APPROVED DRAWINGS HAVE BEEN RED LINED INDICATING A CHANGE TO MEET THE OBC. PLEASE REVIEW ALL PAGES TO ENSURE YOU ARE PROPERLY INFORMED OF CHANGES.

TOWNSHIP OF NORTH DUMFRIES BUILDING DEPARTMENT

These Plans have been examined for Compliance with the Ontario Building Code requirements. A Building Permit has been Issued, subject to any changes noted, under the condition that the building will be constructed in accordance with the code.

Tice River Homes
Legacy

A1

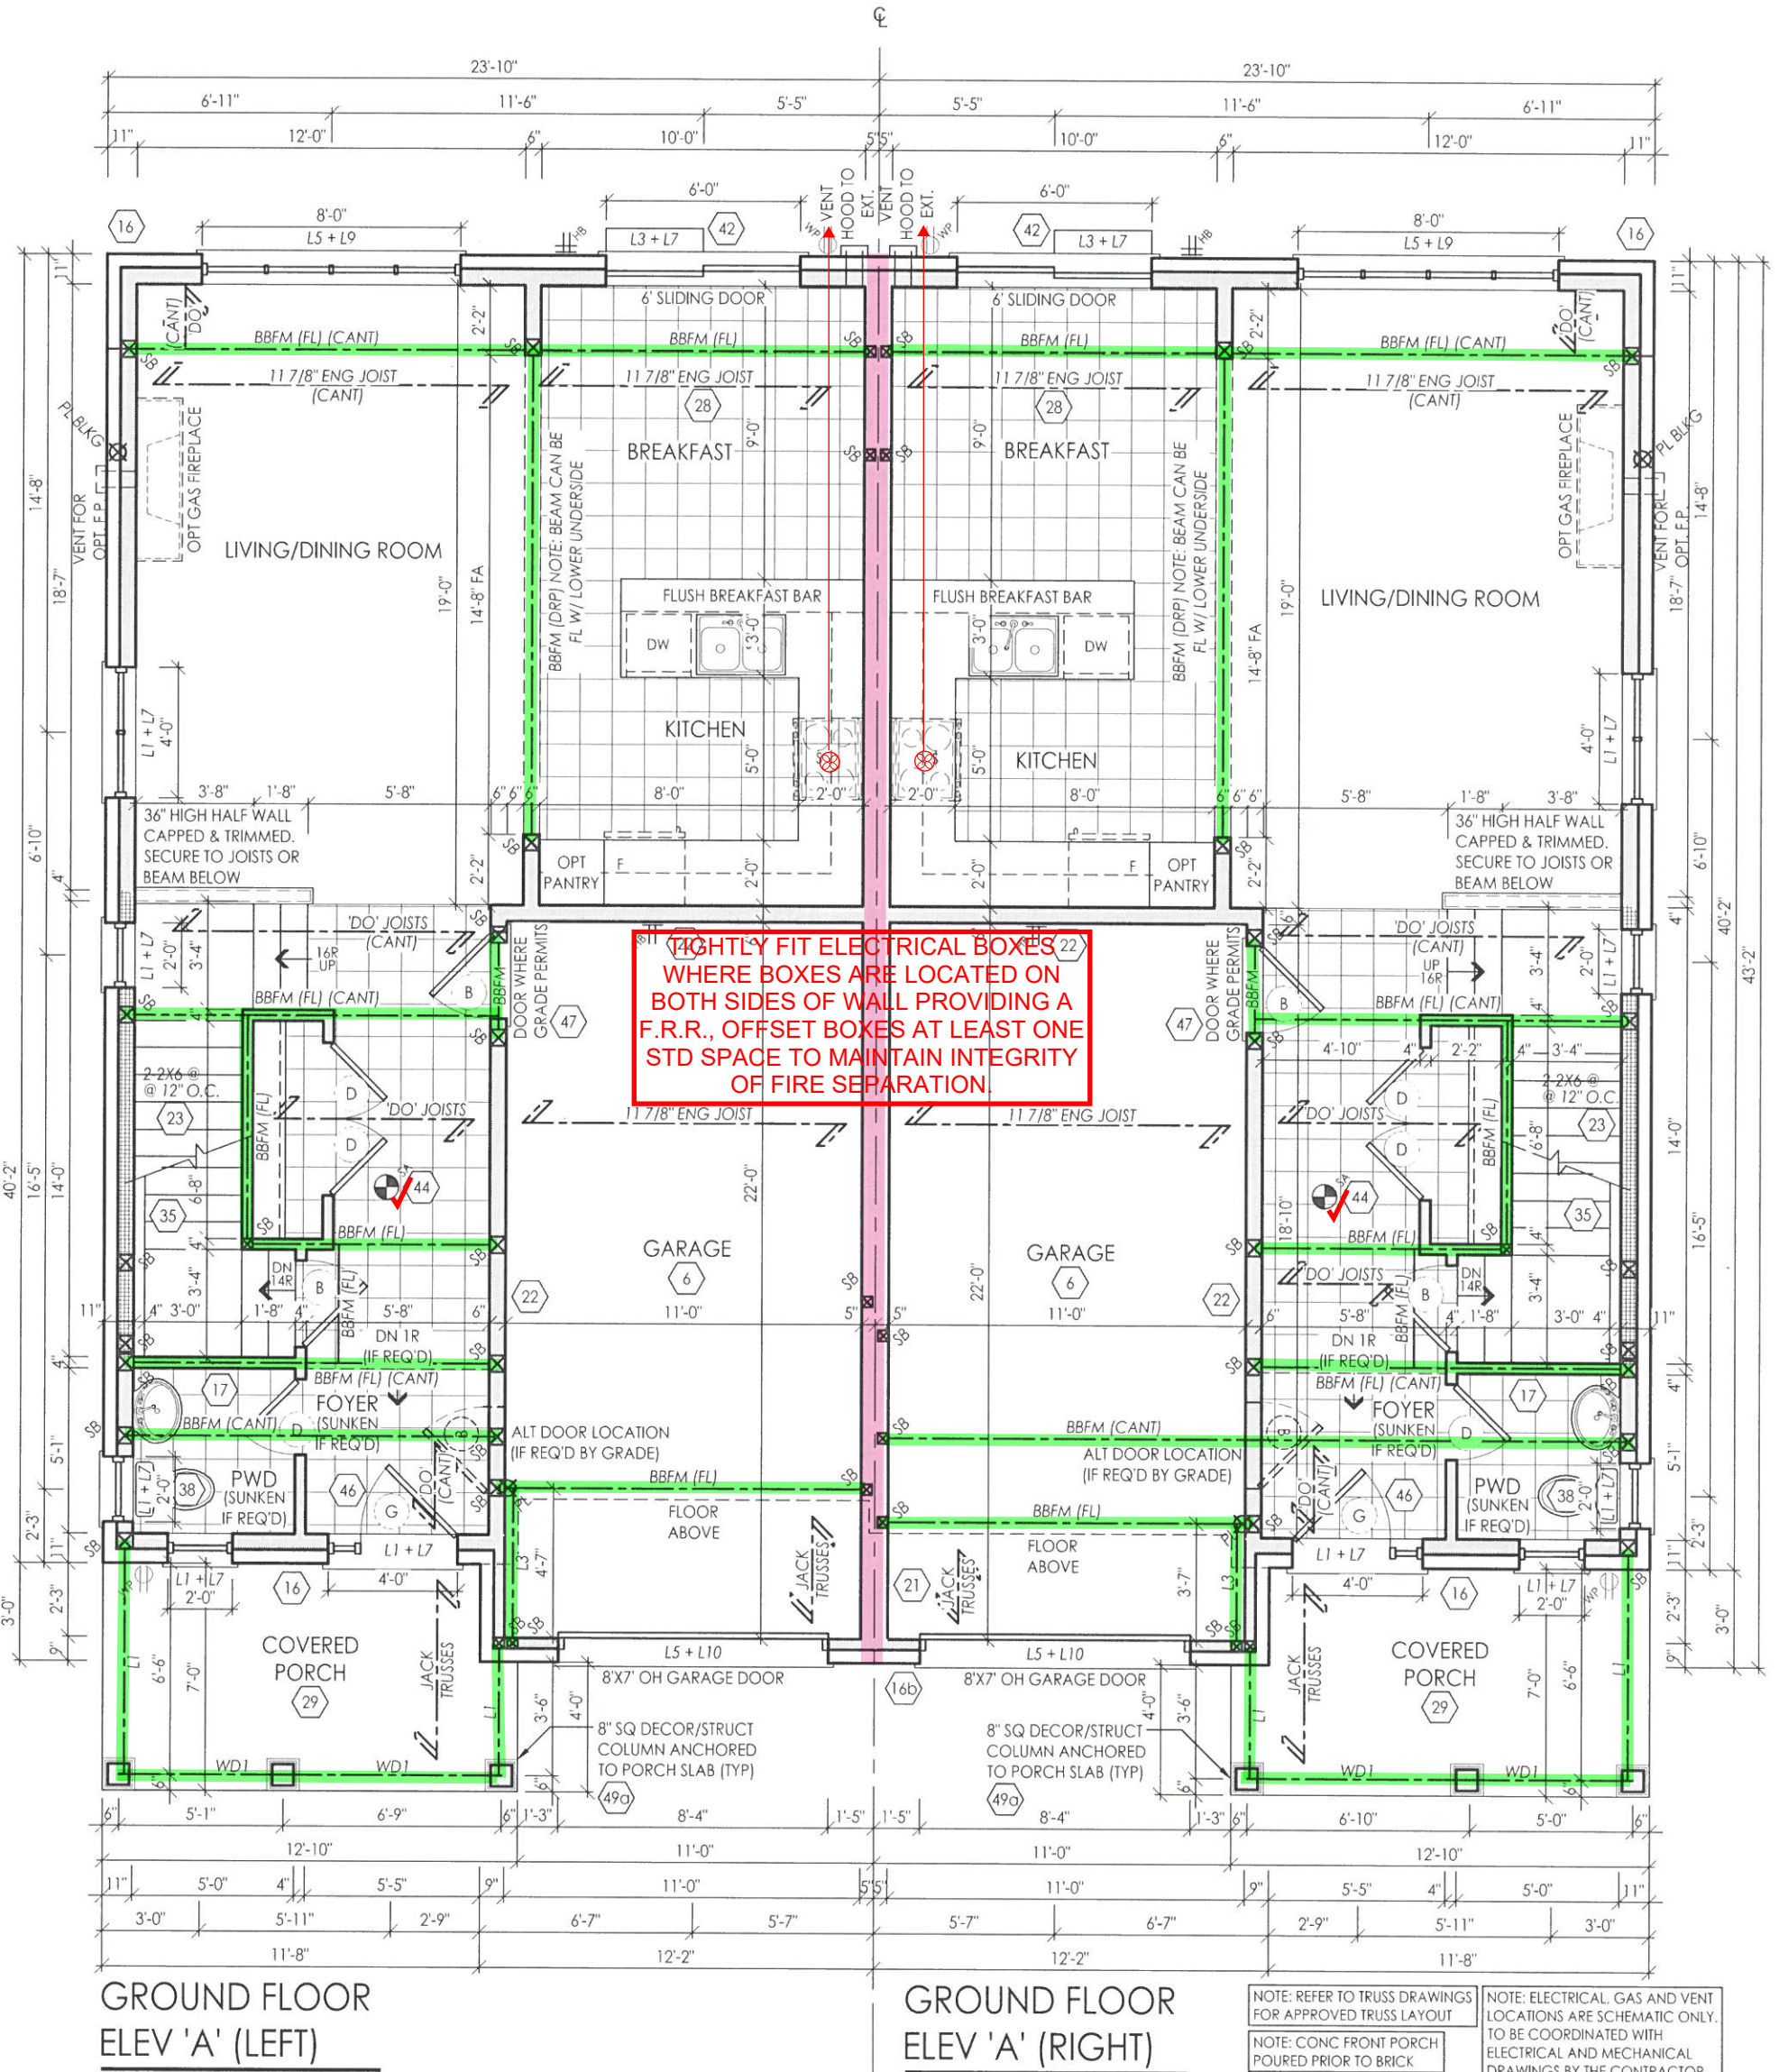
INSULATION IS REQ'D TO BE CONTINUOUS.

A SEPARATE BUILDING PERMIT WILL BE REQUIRED TO FINISH THE BASEMENT.

SUMP PUMP LIDS, JOINTS AT INTERSECTIONS & ALL PENETRATIONS OF SLAB MUST BE SEALED TO PREVENT AIR LEAKAGE.

THE COLD CELLAR DOOR NEEDS TO BE INSULATED AND WEATHER-STRIPPED.

location: Ayr
 project: Legacy
 marketing name: Legacy
 model: SD-01
 scale: 3/16" = 1'0"
 project #: 17052
 page: **A3**

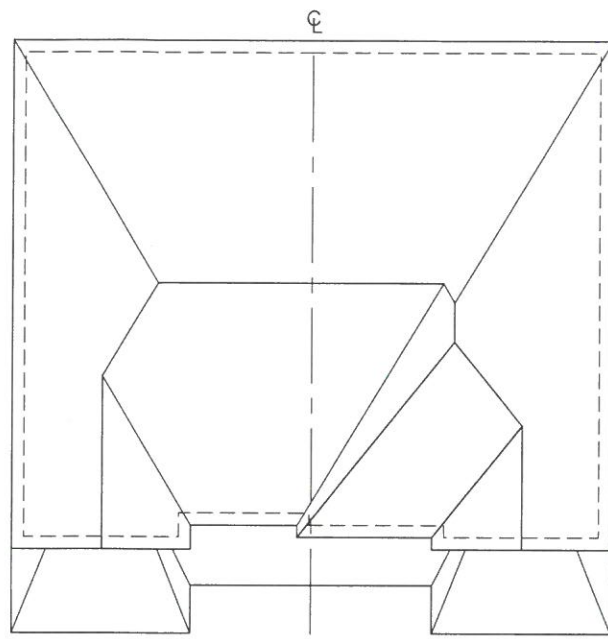
REINFORCEMENT REQUIRED IN MAIN BATHROOM STUD WALLS TO PERMIT THE FUTURE INSTALLATION OF GRAB BARS.

NON CONBUSTABLE CLADING REQ'D
